HORSHAM DISTRICT COUNCIL CONSULTATION

TO:	Horsham District Council – Planning Dept
LOCATION:	Mowbray Old Holbrook Horsham West Sussex
DESCRIPTION:	Discharge of schedule 4, part 5, clause 1.1 (open access ball courts) and schedule 4, part 6, clause 1.1 (neighbourhood equipped area of play) of the S106 agreement (DC/16/1677) in connection with phase 2
REFERENCE:	S106/26/0020
RE-CONSULT:	1 st set of comments in black 2 nd set of comments in blue
RECOMMENDATION:	Holding Objection / Advice Holding Objection / Advice

SUMMARY OF COMMENTS & RECOMMENDATION:

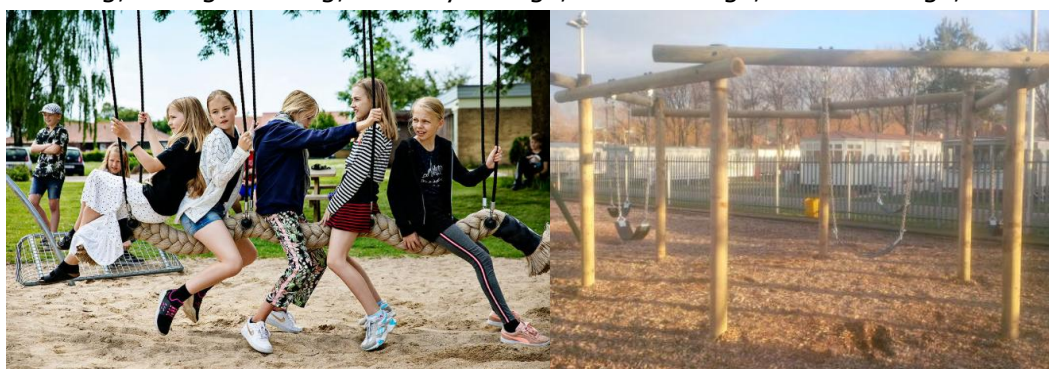
7. Please consider an alternative design for the castle tower as current proposals may encourage bullying or sleeping within its enclosure. See below as a preferred example of a more open design:

Response dated 02/06 is noted. We continue to recommend the above and hope it is considered during reserved matters.
